**ANN ARBOR HISTORIC DISTRICT COMMISSION****Staff Report****ADDRESS:** 834 West Washington Street, Application Number HDC12-047**DISTRICT:** Old West Side Historic District**REPORT DATE:** April 30, 2012**REPORT PREPARED BY:** Katie Remensnyder, Interim Historic Preservation Coordinator**REVIEW COMMITTEE DATE:** Monday, May 7 for the Thursday, May 10, 2012 HDC meeting**OWNER**

**APPLICATION:** The applicant seeks HDC approval to replace thirteen existing wood windows with Renewal by Andersen energy efficient windows and replace the exterior trim around each window.

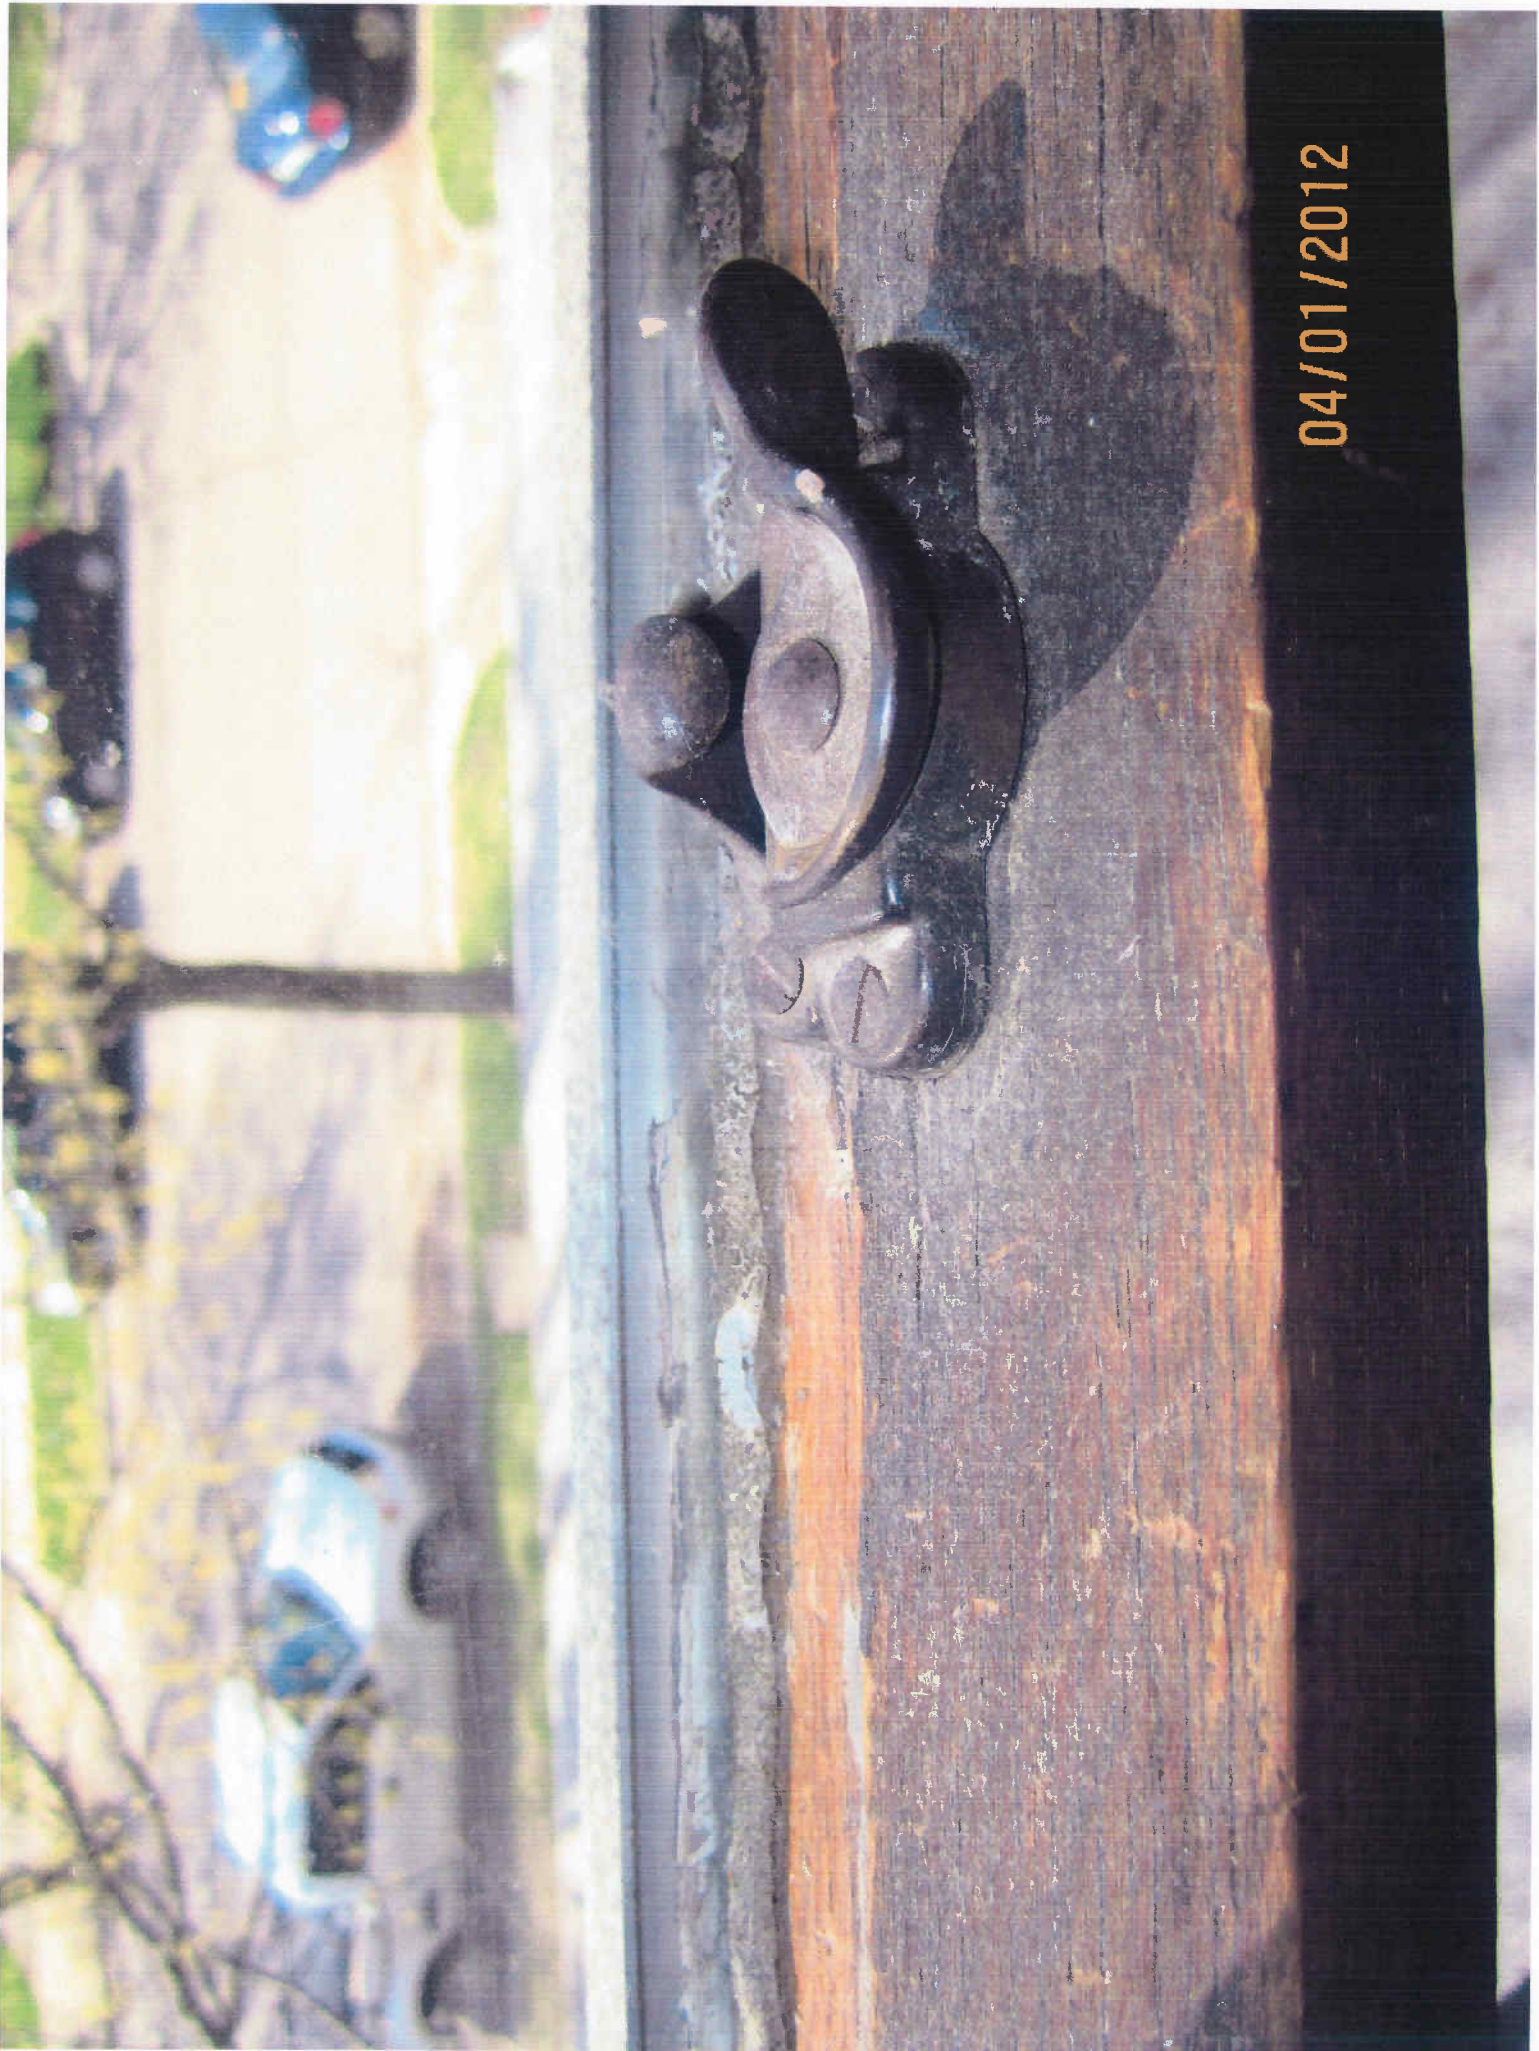
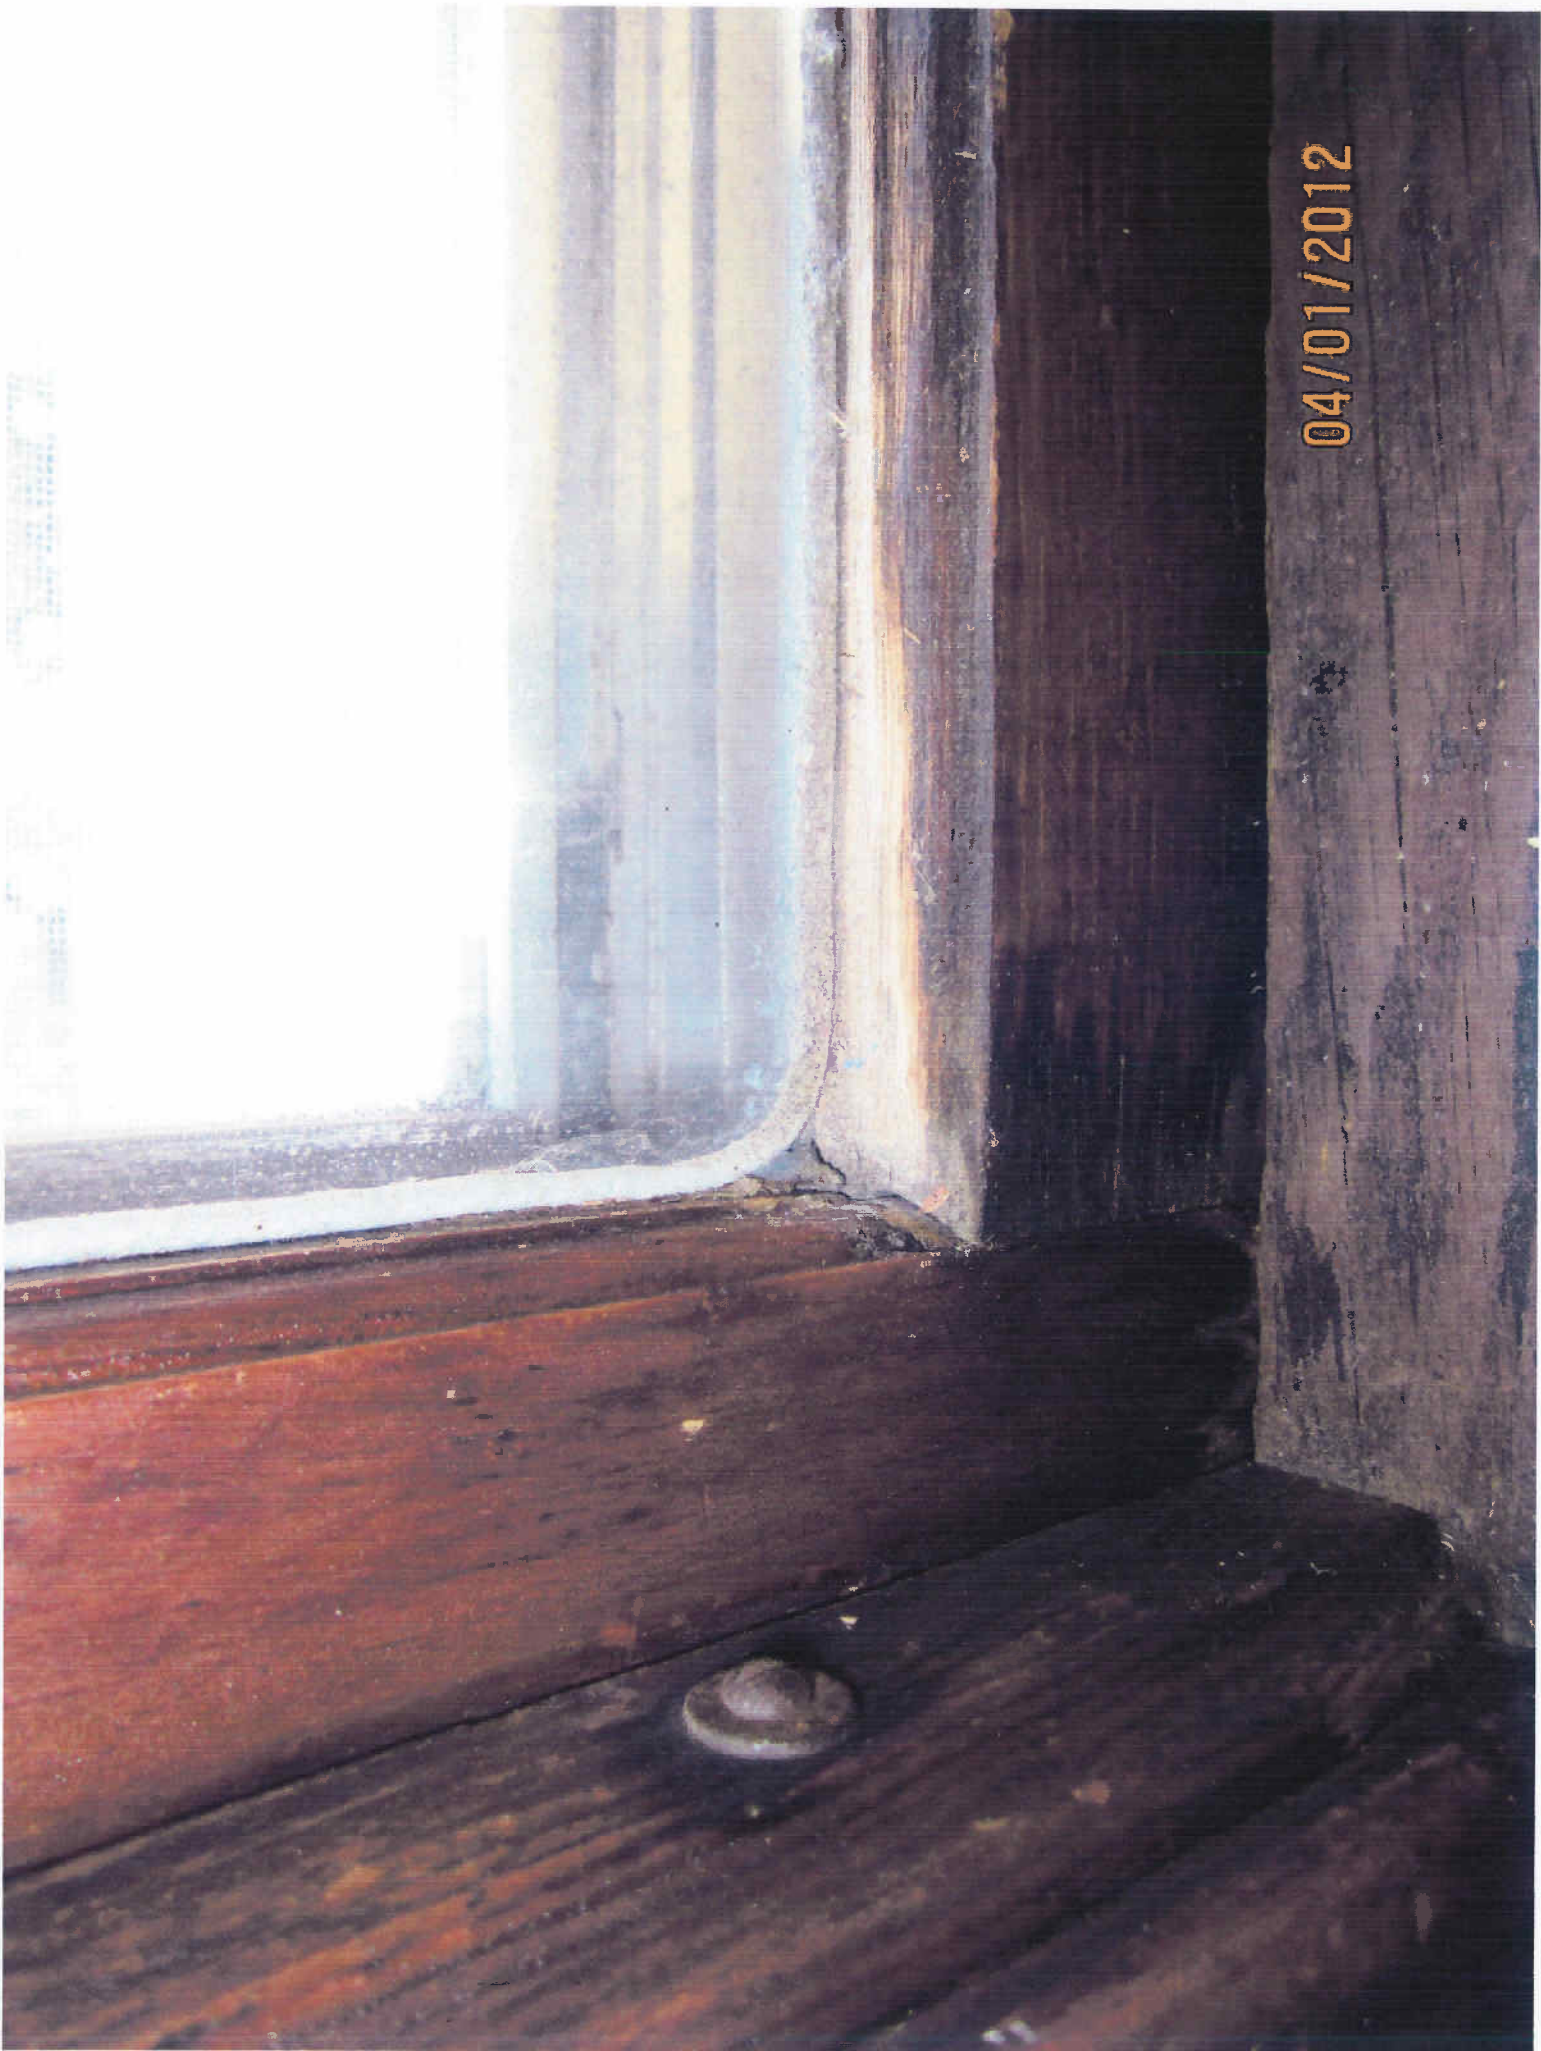
1. The windows that are proposed to be replaced are located on all four elevations and are character-defining features of the house. Based on submitted photographs, there appears to be a small amount of rot present on at least one window. The applicant states that other windows exhibit some amount of rot, loss of glazing compound, and water infiltration. Staff has not yet visited the site to review the windows and no assessment of each individual window has been submitted at the time this report was prepared.
